Notice: KX* Series Component Material Changes

Please note the below material changes for the following KX* series part numbers:

Plating Material Changes

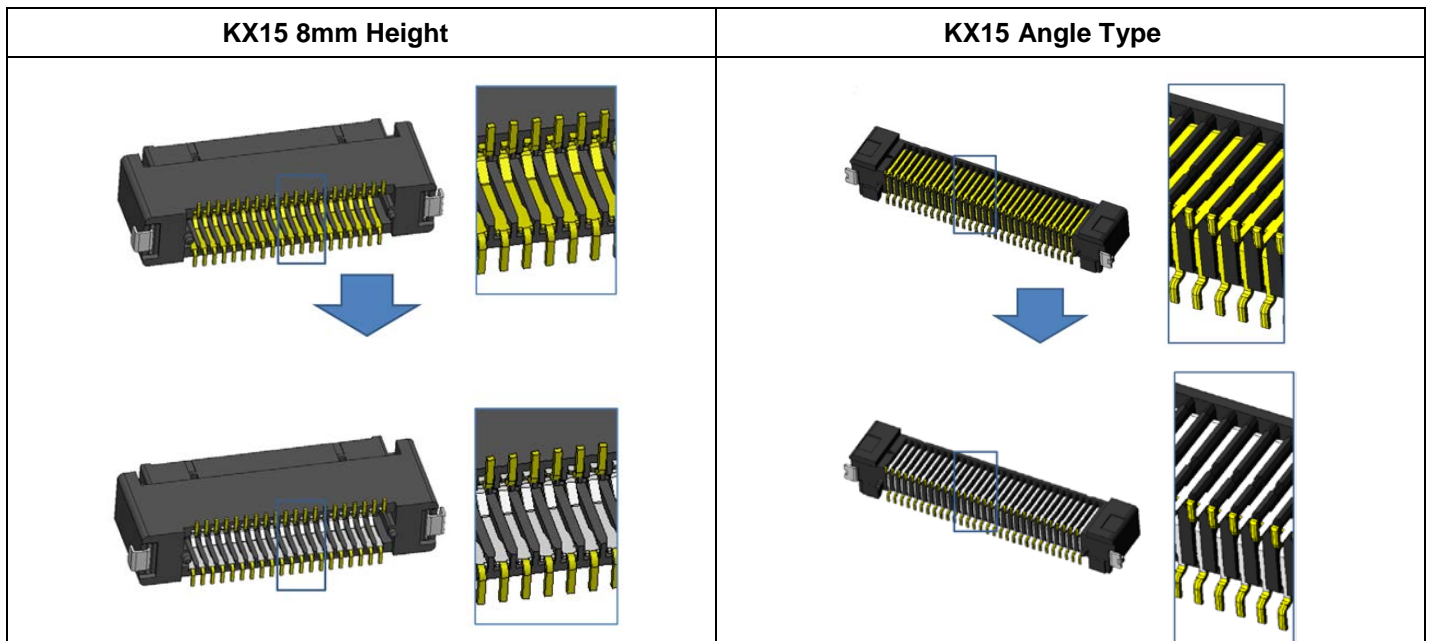
KX15 Straight K8 Type and Angle Type			
	Contact Area	All Other	SMT Area
Current	Ni over Au	Ni over Au	-
New	Ni over Au	Ni	Ni over Au flash
